ORIGINATION FORM

Proposed Revisions to a Standard Plans Index

Index Number: 550-012

Index Title: BRIDGE FENCING (ENCLOSED)

LAST REVISION 11/01/17	DESCRIPTION:	 FY 2023-24 STANDARD PLANS	BRIDGE FENCING (ENCLOSED)	INDEX 550-012	SHEET 1 of 4
---------------------------	--------------	---	---------------------------	------------------	-----------------

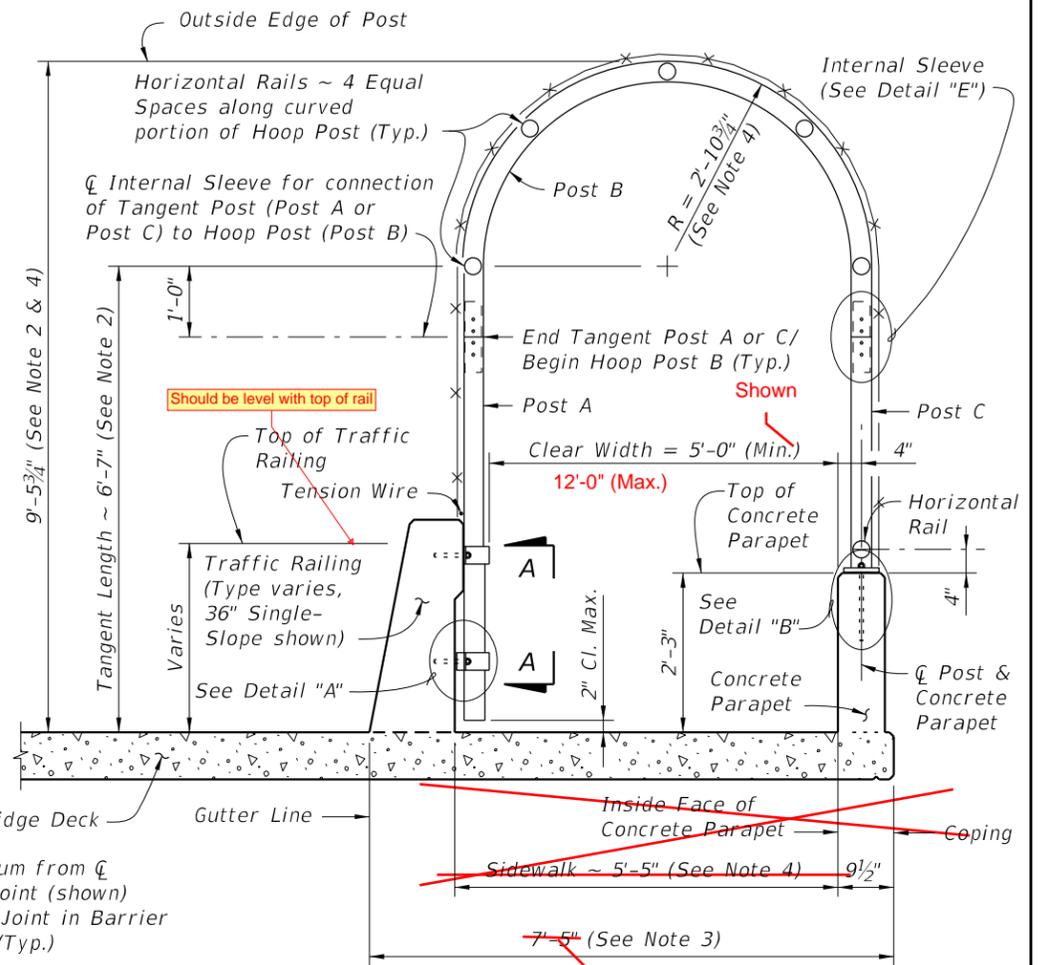
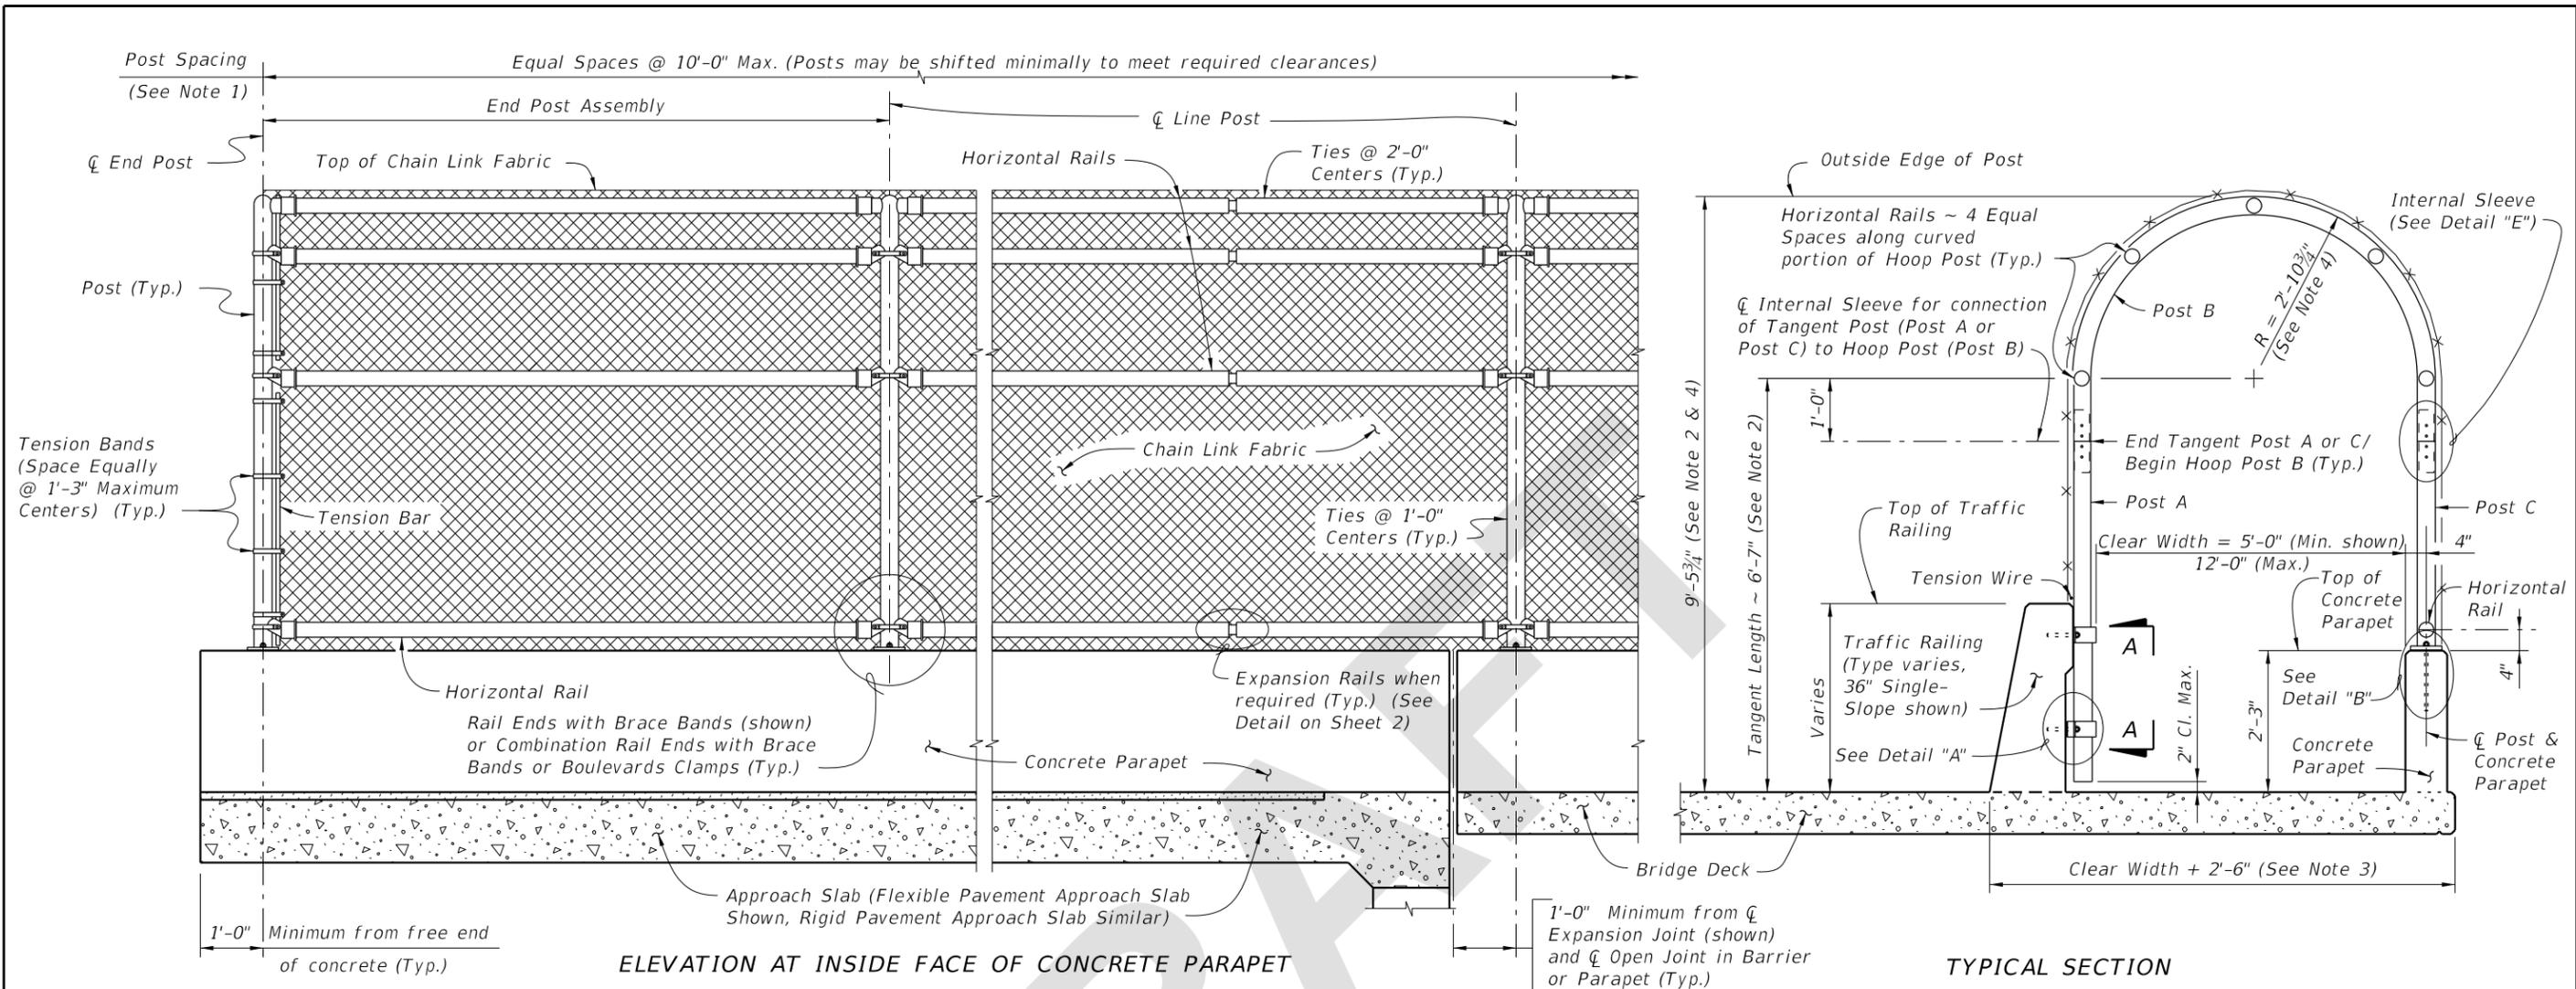
Sheet 1: Replaced the 7'-5" dimension because the calculated dimension is off by 3/8" and the dimension varies depending on clear width; Removed the 5'-5" dimension because it varies; Changed all instances of the word sidewalk to pathway; Revised the Clear Width note from 5ft min to add 12 ft max.

An email came it that highlighted that the calculated dimensions do not match the Standard. It was determined that the dimensions were not required as they vary and recording them to the 1/8" would not be an ideal solution.

Sidewalk may have special FDM connotations. Therefore, we used a more general term.

Standard allows for extension of the fencing for larger widths but those widths are not unlimited so we added a maximum of 12 ft.

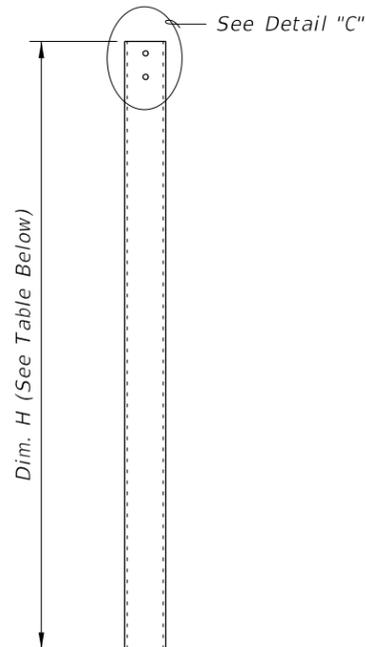
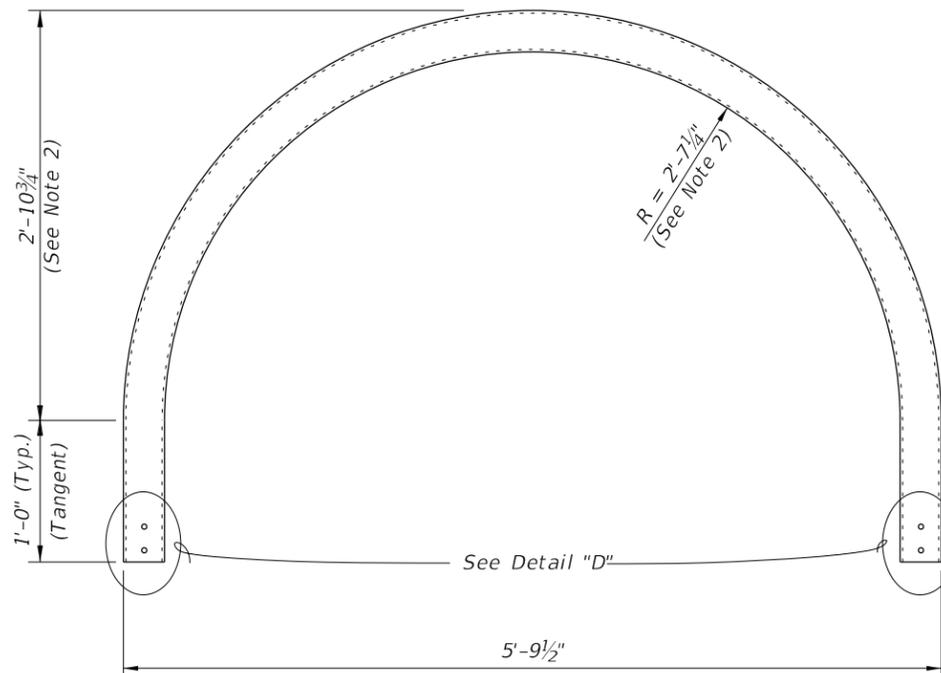
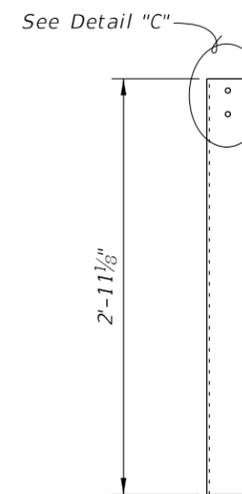
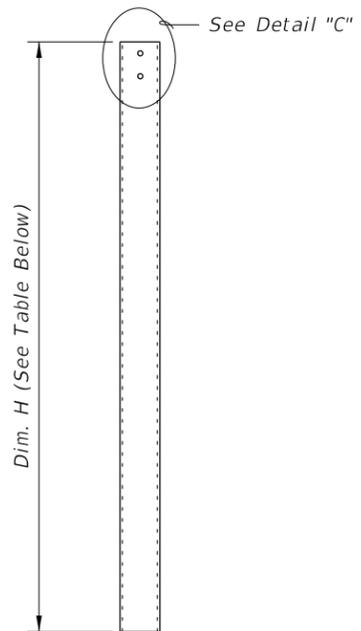
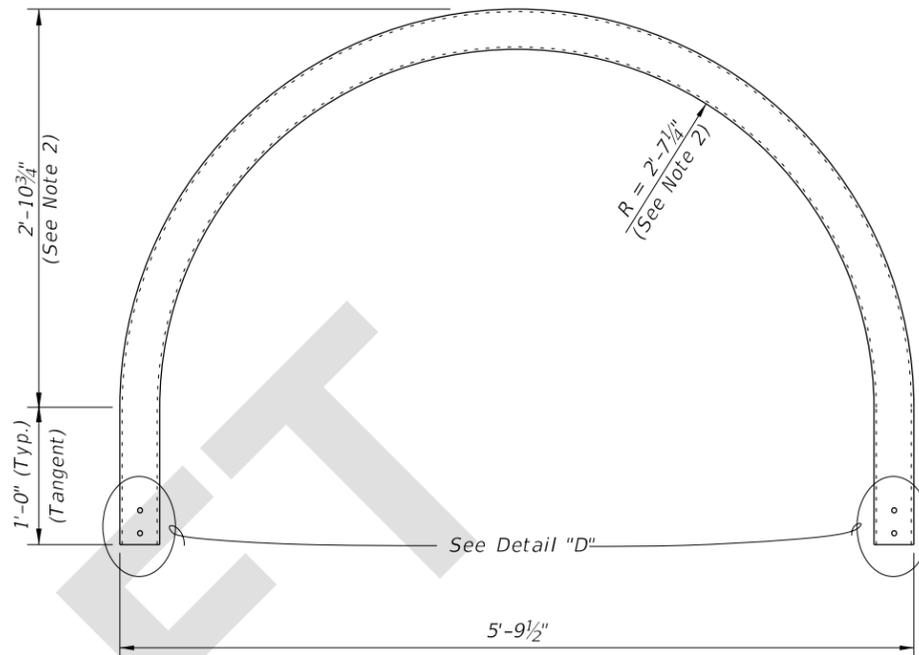
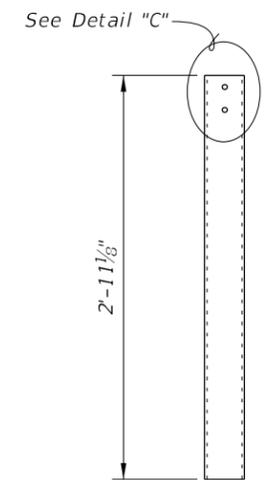
Sheet 2: Changed all instances of the word sidewalk to pathway.
